**CERTIFICATE OF APPROPRIATENESS****Application Date:** February 3, 2016**Applicant:** Alexander Ridgway, Brickmoon Design, for Thomas and Rachel Paez, owners**Property:** 835 Columbia Street, Lots 2& 3, Block 250, Houston Heights Subdivision. The property includes a 2,429 square foot, two-story wood frame single-family residence and detached garage situated on a 13,200 square foot (100' x 132') double interior lot.**Significance:** Noncontributing altered bungalow residence, remodeled circa 1980, located in the Houston Heights Historic District South. The noncontributing structure will be demolished.**Proposal:** New Construction – *Deferral*

Construct a new 3,758 square foot 1½ story residence and new rear detached two-story 1,219 square foot garage.

**Context Area:** The context area for this application is the 800 block of Columbia Street, both west and east blockfaces. See pp. 5-9 for further analysis of the context area.**Public Comment:** No public comment received.**Civic Association:** No comment received.**Recommendation:** Denial - does not satisfy criteria 2 and 3**HAHC Action:** Denied

**SOUTH SIDE ELEVATION**

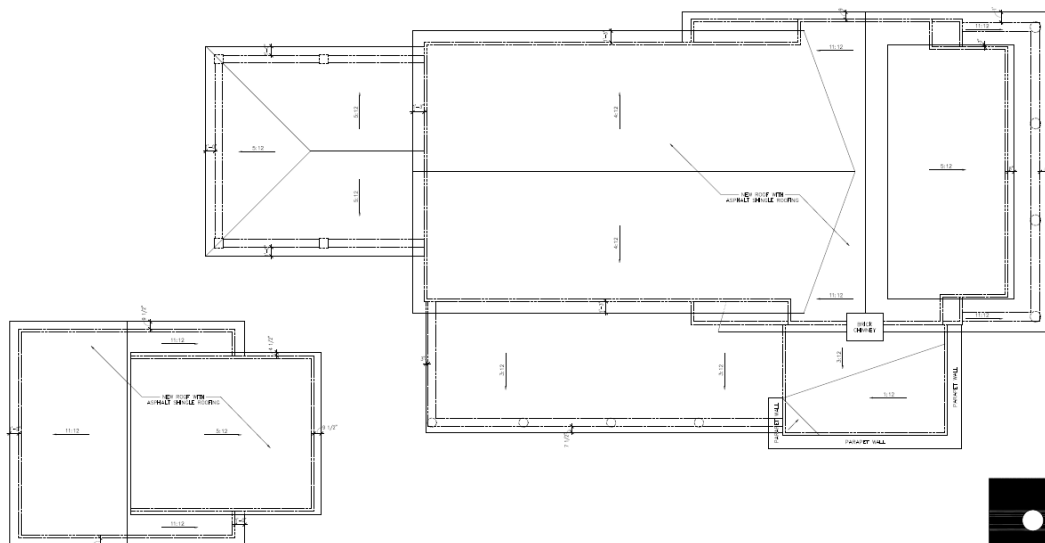
- The exterior features of the proposed residence are not compatible with the existing contributing structures in the context area. The main body of the house features Craftsman-type details, with four-over-one windows on the first floor and six lite windows in the dormer. However, on the south side of the house is a 12' wide by 18' deep one-story extension, located 1'-7" back from the front wall of the house, that is of a different style. This extension features a configuration of columns, panels, parapet, multi-paned windows, and flat roof more commonly found on Greek Revival architecture. This style is not only incompatible with the house itself, it is also incompatible with the existing contributing structures in the context area, which are a combination of simple Craftsman bungalows and Queen Anne houses. The proposed divided-lite windows on both the main body of the house, the dormer, and the side extension are not found in the context area; contributing houses in this area have a simpler lite-pattern, 1-over-1 for Craftsman and 2-over-2 for Queen Anne being typical.

- In order to meet this criterion, this side extension would need to be clad in a manner consistent with the rest of the house (such as lap siding), have a more compatible side gabled roofline, and feature 1-over-1 windows. The windows on the house should also feature a simpler lite pattern than the proposed 4-over-1 windows or the six lite windows in the dormer.

- The proposed new residence is not in scale with the contributing structures in the context area. Typical width ranges from 26' to 32' on the blockface. Although the 33' width of the main portion of the house is close to the typical range for contributing structures, the one-story extension located almost flush with the front wall of the house brings the house to a total 45' in width, which exceeds the typical width in the context area by over 10'.

- Based on Sanborn maps, aerial photos, and other research, staff has found no evidence to suggest that larger lots contain wider structures in the context area or in the historic district overall. Even the subject property originally contained two houses of typical width, one on each lot. Also, the proposed flat roof of the south extension is not compatible with other contributing structures in the context area.

- Furthermore, the applicant is proposing a 13' deep and 39' long open porch on the south side of the house. Because the elevations currently have this porch tucked behind the proposed south extension, it's unclear how much visual impact the side porch would have if this extension were

removed or reduced as needed to meet Criterion 3. Staff recommends that this feature also be denied unless the applicant provides drawings demonstrating the visual impact of the porch if the south extension is not constructed.

- **Remove the 12' south extension. This will bring the house's width into appropriate range, and will eliminate the problem with the discordant architectural styles between this extension and the rest of the house and context area.**
- **Remove or reduce the size of the side porch currently proposed behind the south extension, as this contributes greatly to the overall width of the house and the applicant has not demonstrated the visual impact of the porch should the south extension be eliminated.**
- **Choose windows with a simpler lite pattern, preferably 1-over-1 wood windows.**
